Project Description Update Addendum

Corby Battery Energy Storage System Project

May 2025

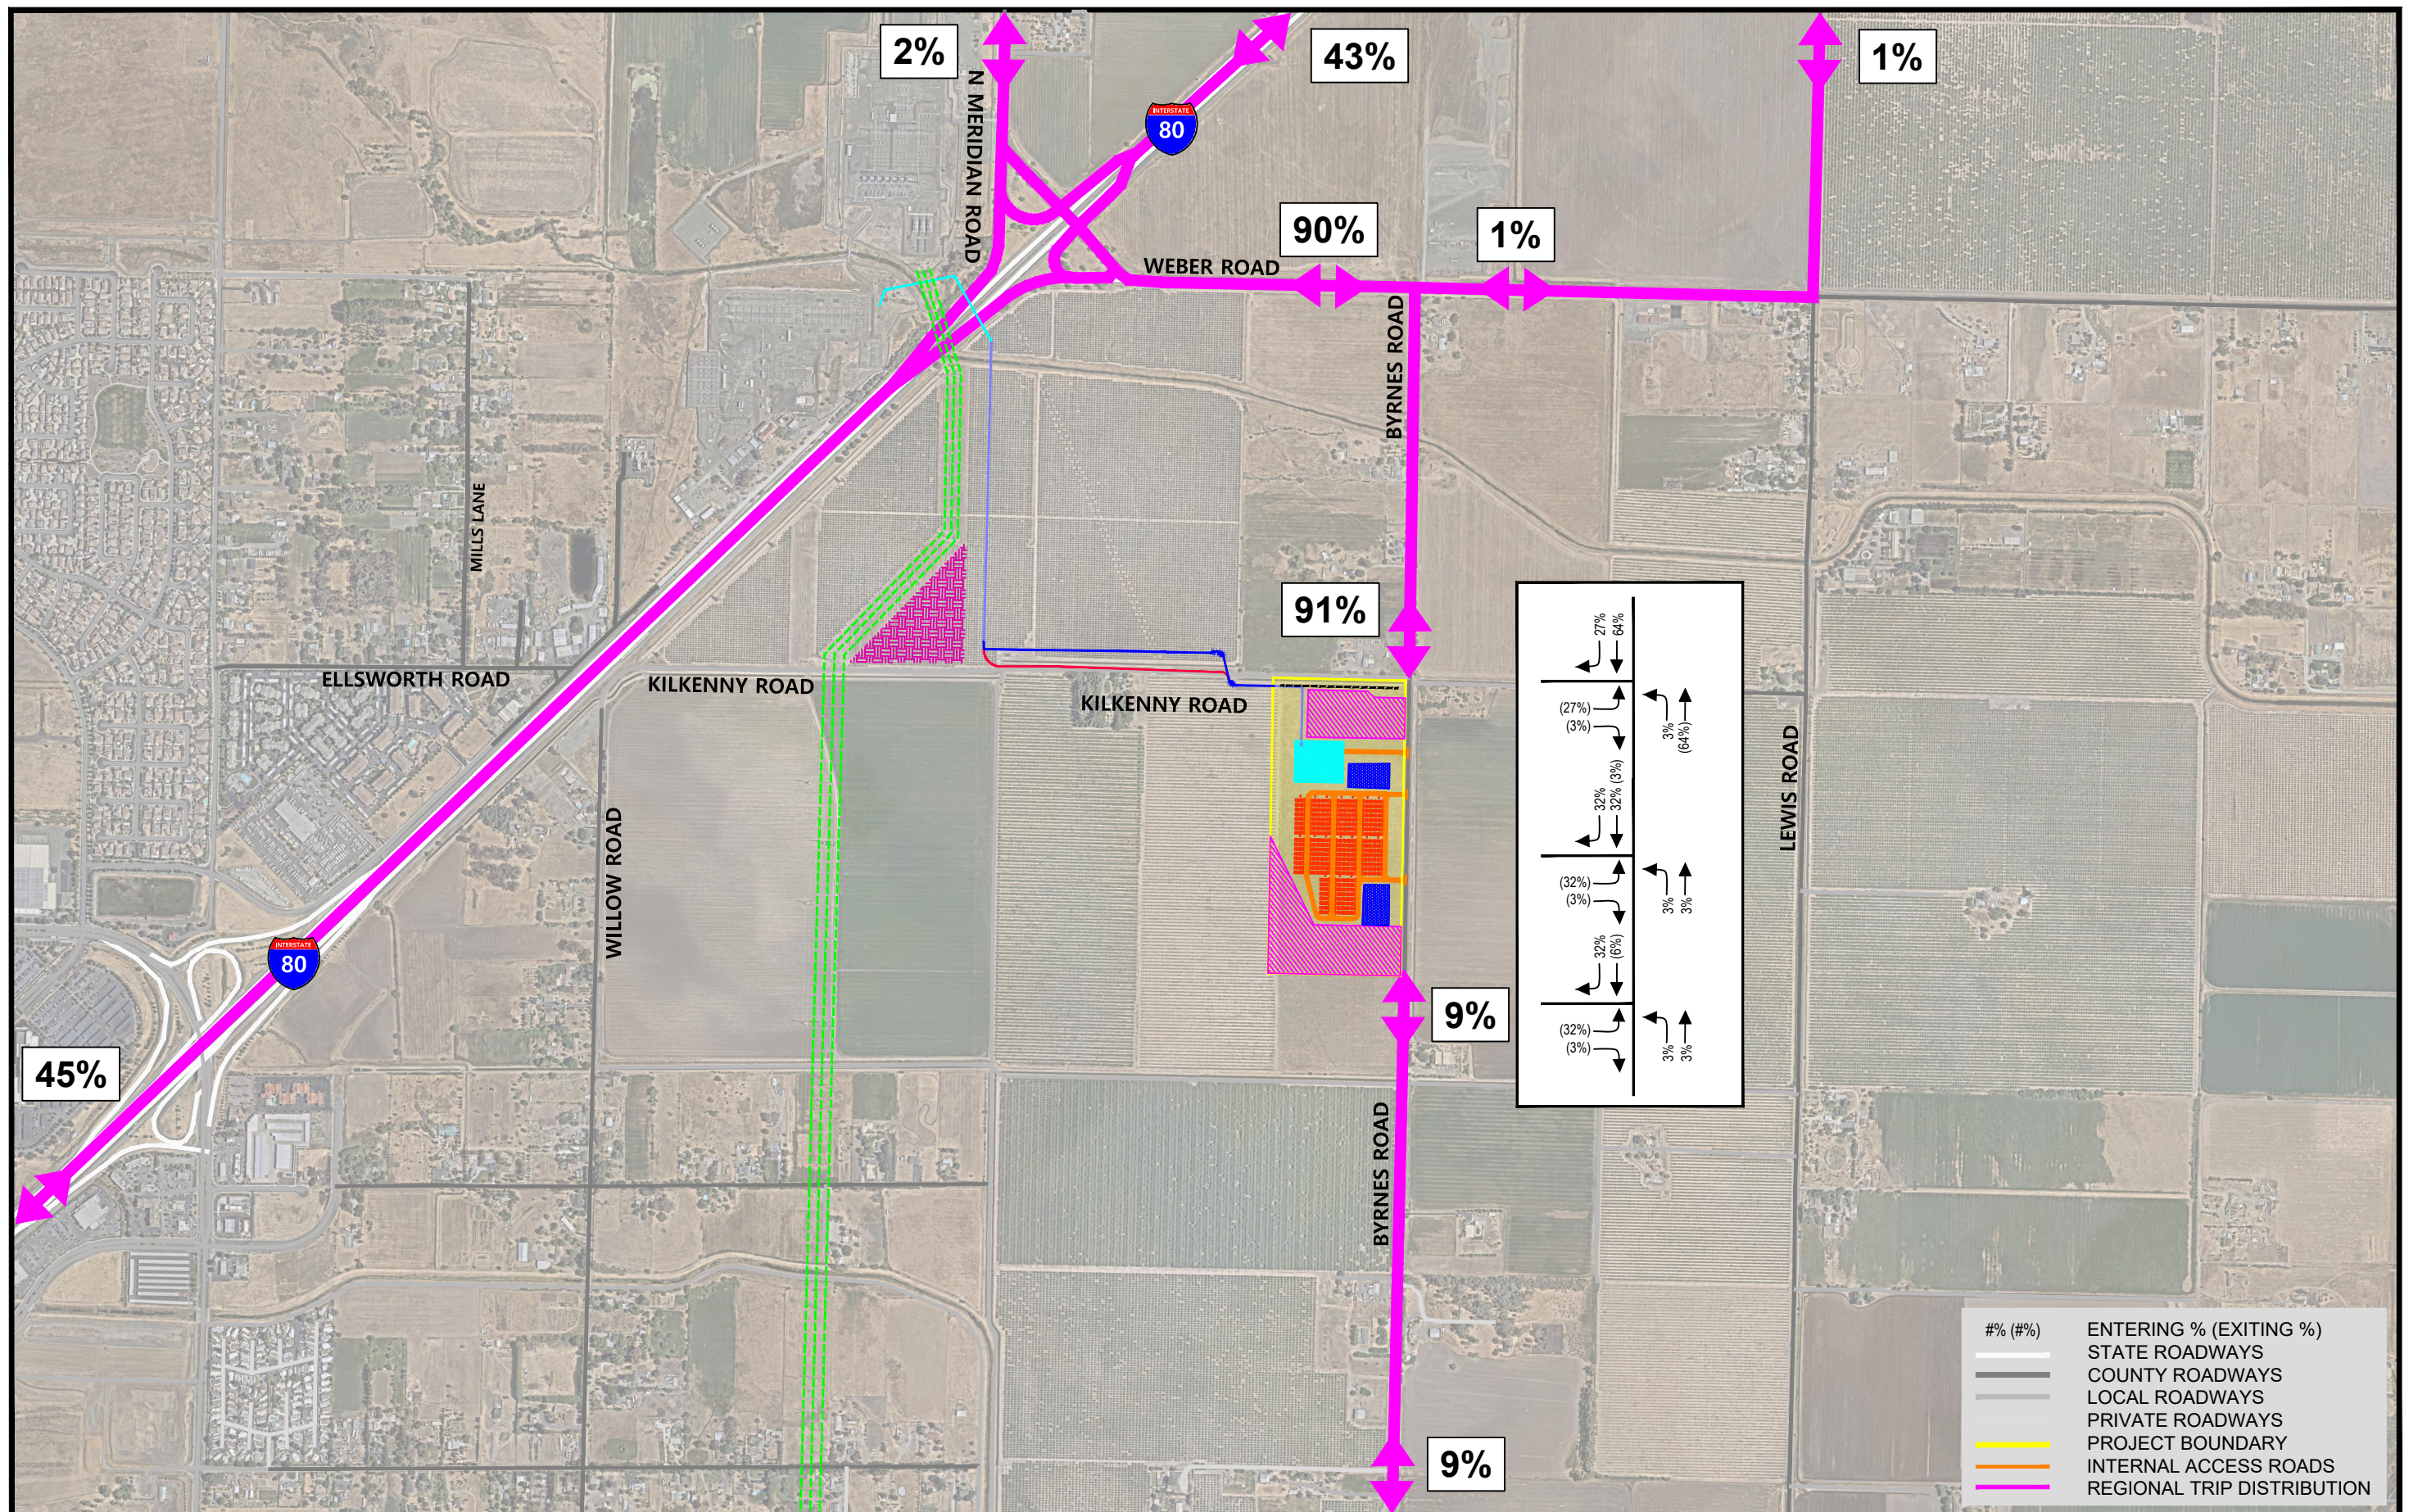
The updated Project trip distribution patterns to and from the Project site within the study area are shown in Figure 3.17-1 (replaces Figure 4.17-6 in the Application). The updated trip distribution patterns were then applied to the trip generation estimates previously summarized in Table 3.17-1 herein. The resulting updated Project peak construction peak hour trip assignment is shown in Figure 3.17-2 (replaces Figure 4.17-8 in the Application).

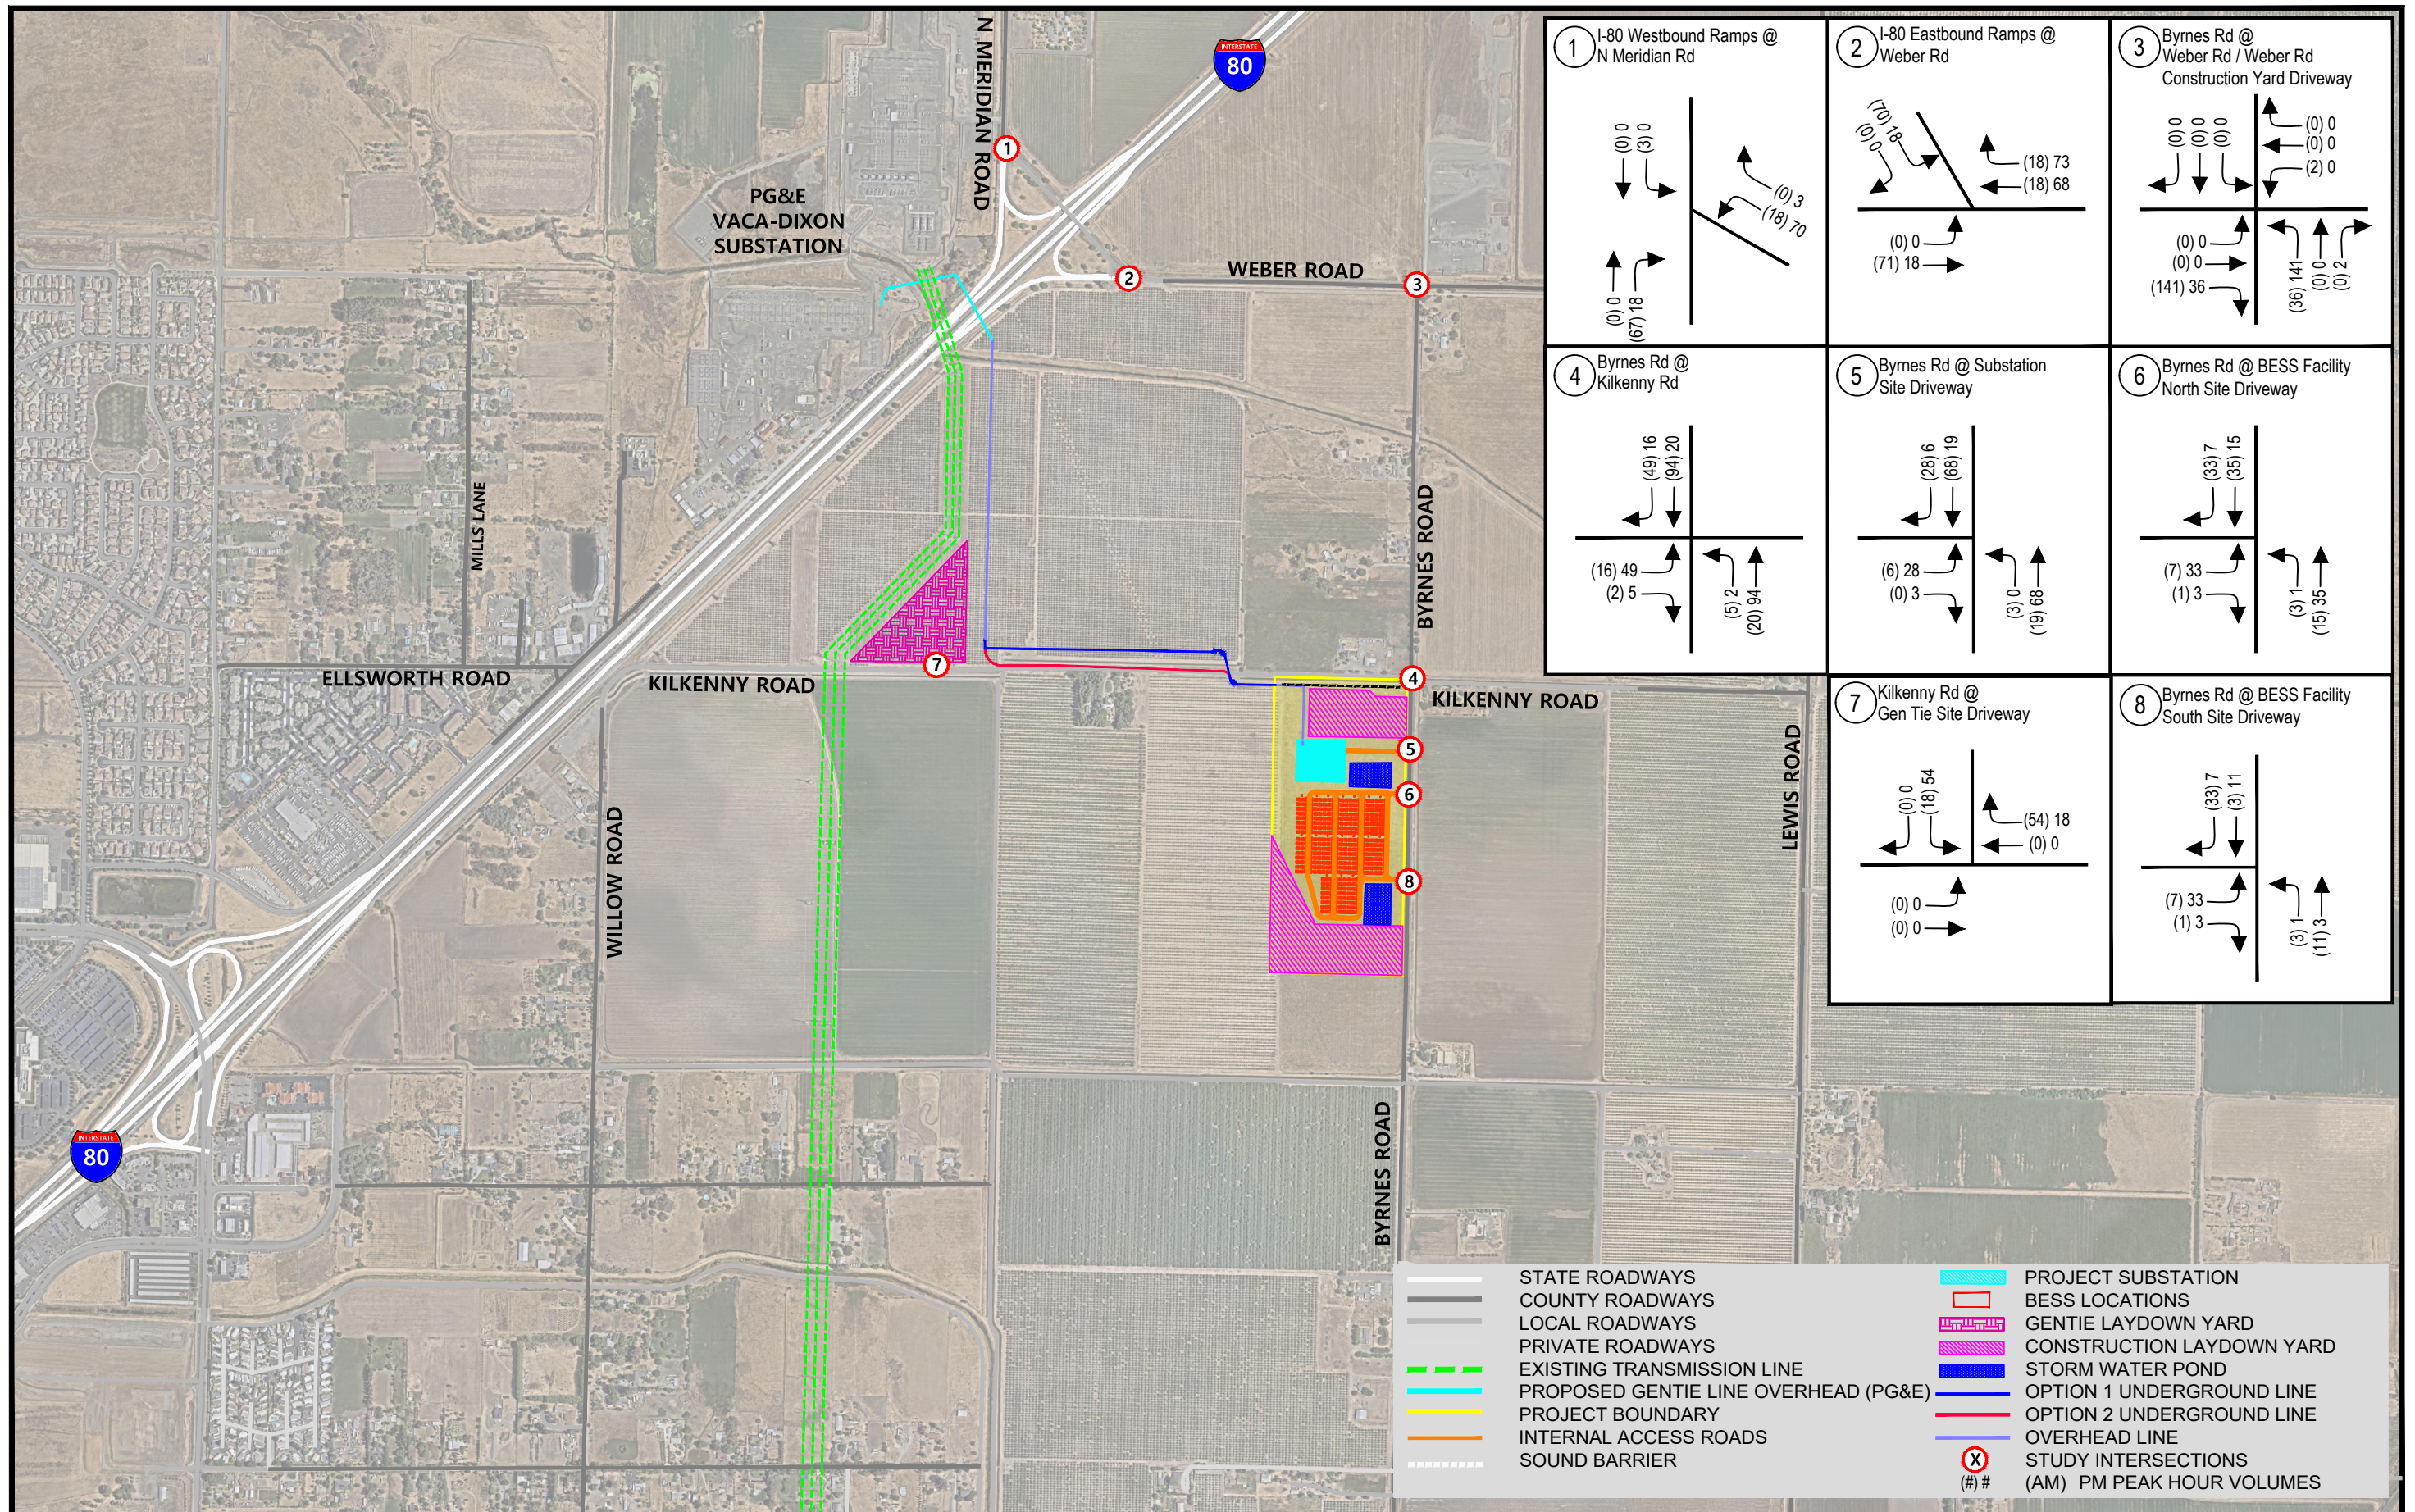
Project trips shown in Figure 3.17-2 were added to the existing traffic volumes previously shown in the Application to estimate the Existing Plus Project traffic volumes. Figure 3.17-3 (replaces Figure 4.17-10 in the Application) shows the 2024 Existing Plus Project traffic volumes that were used to evaluate Existing Plus Project roadway and intersection operations.

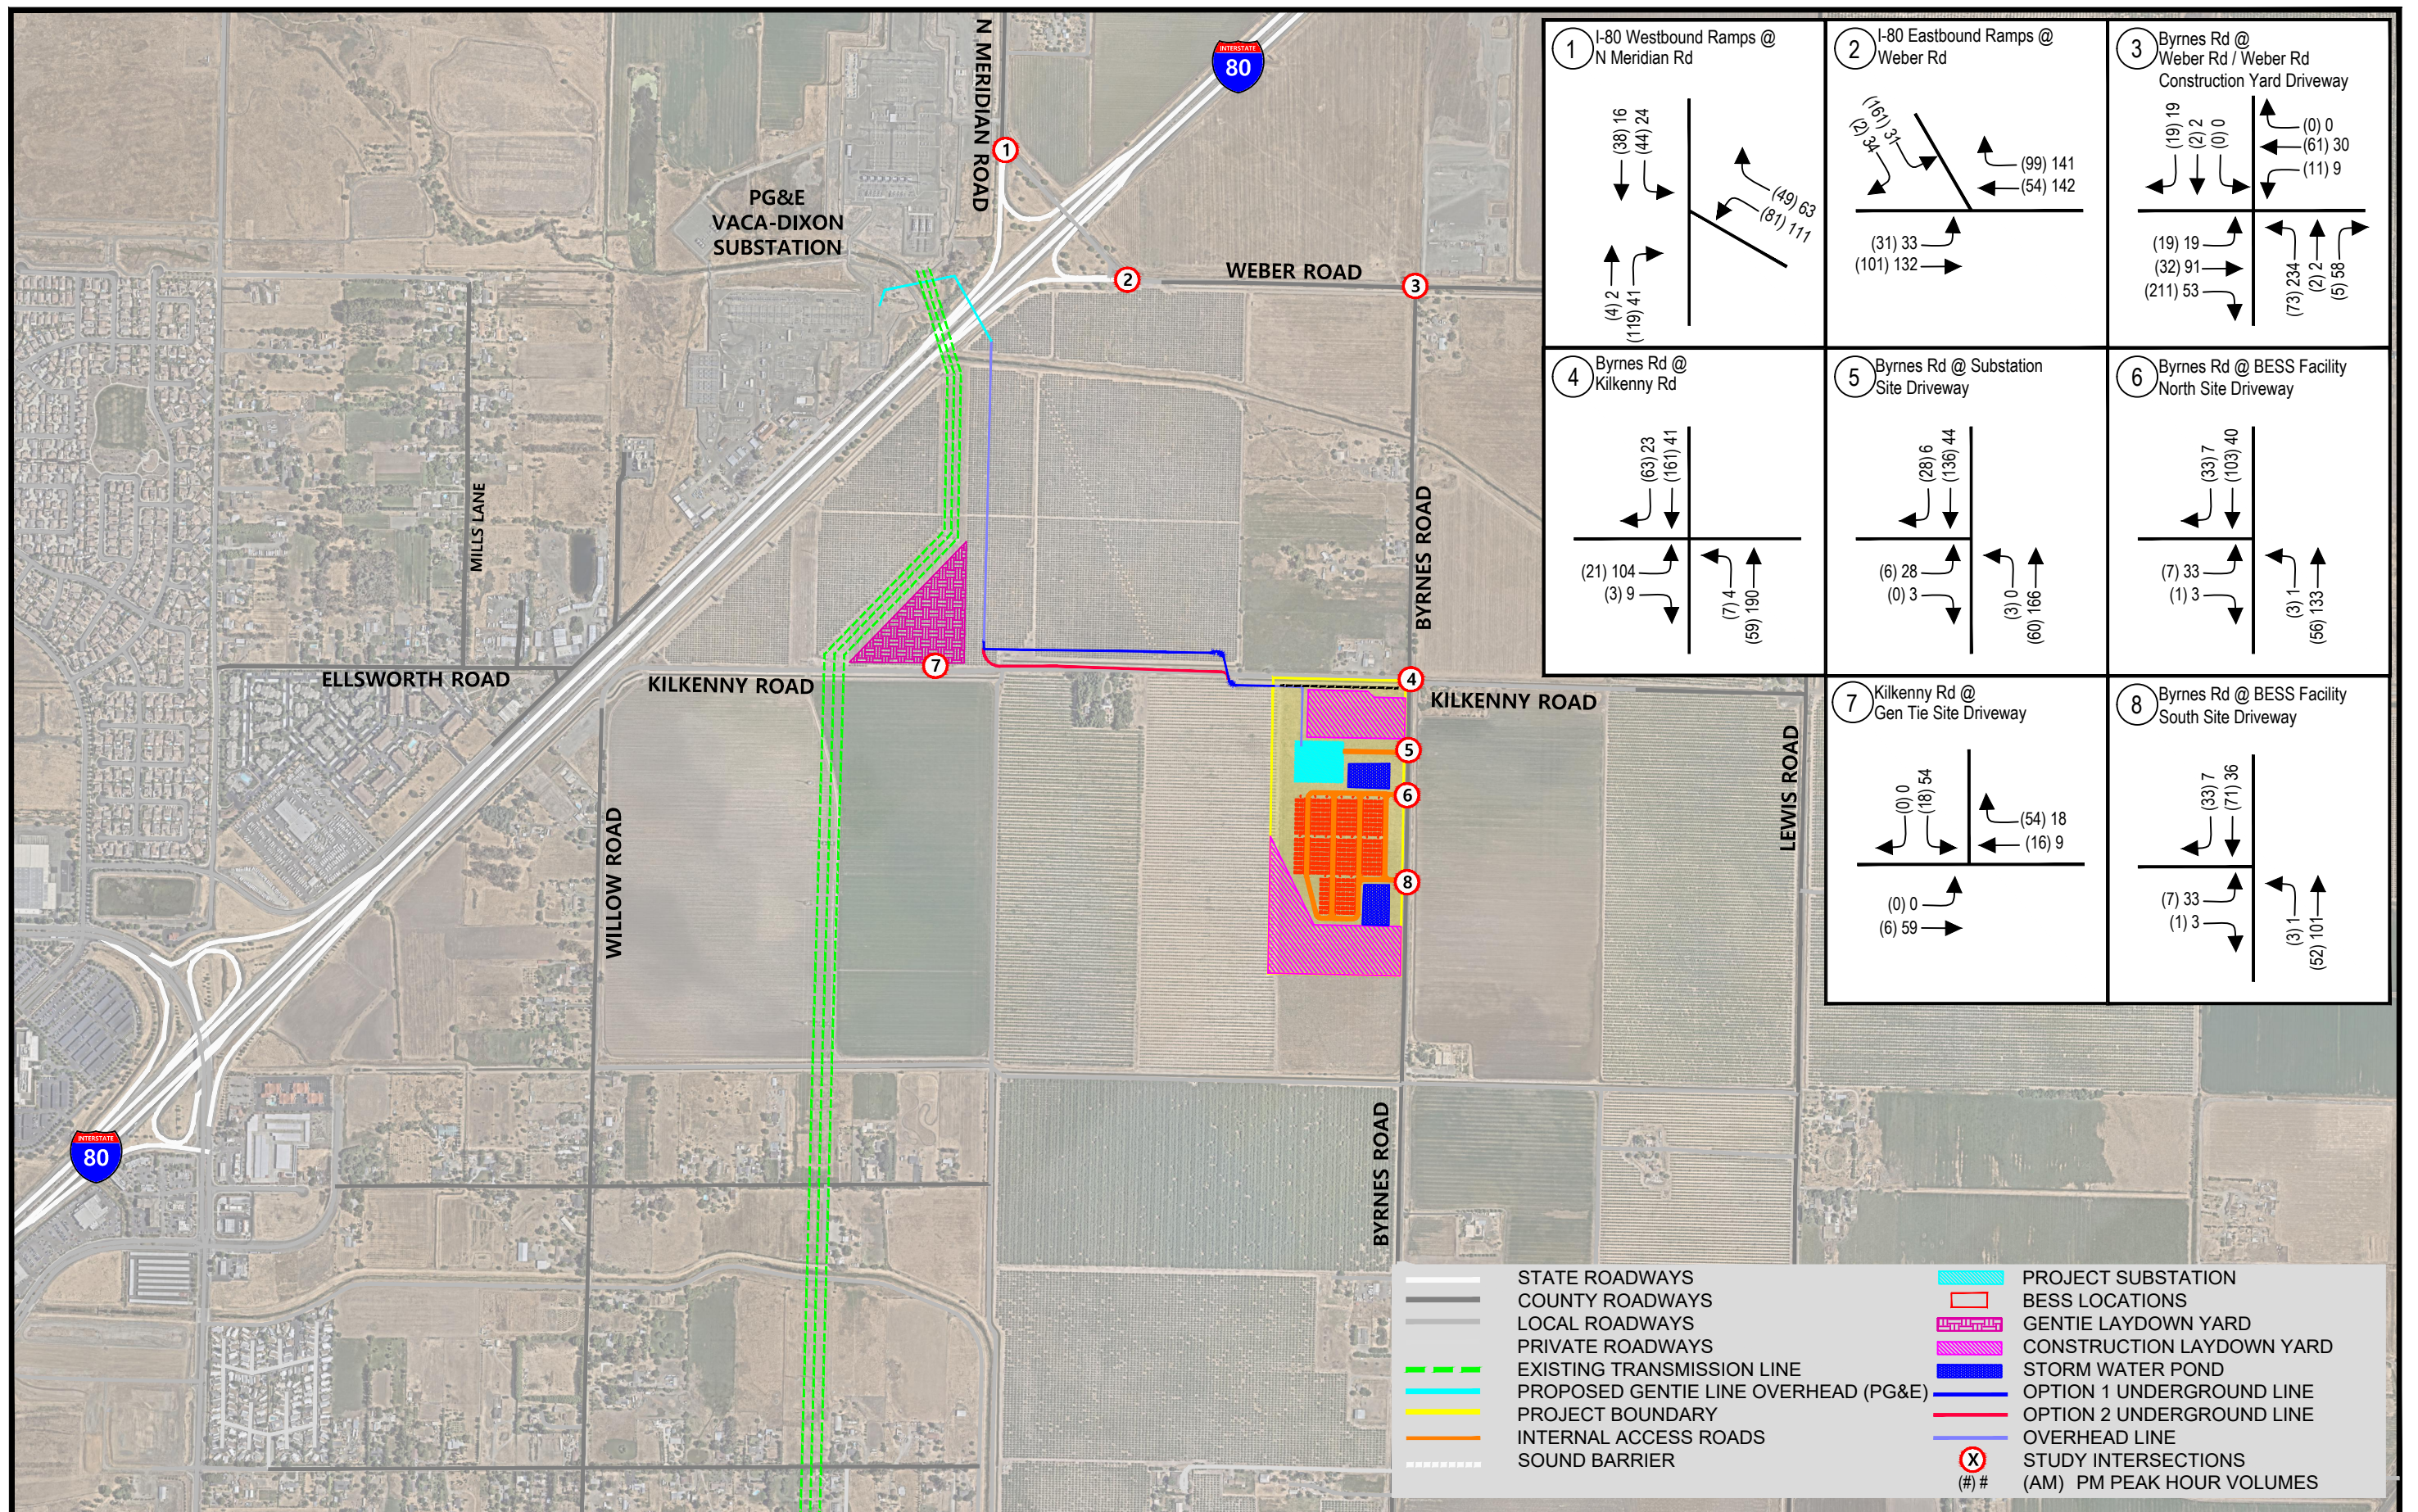
The 2026 Cumulative Plus Project (Peak Construction) conditions consist of Project-related traffic added to the 2026 Cumulative (Without Project) Conditions traffic volumes. Project trips shown in Figure 3.17-2 for peak construction activities were added to the 2026 Cumulative (Without Project) condition traffic volumes previously shown in the Application. The resulting 2026 Cumulative Plus Project traffic volumes are shown in Figure 3.17-4 (replaces Figure 4.17-13 in the Application).
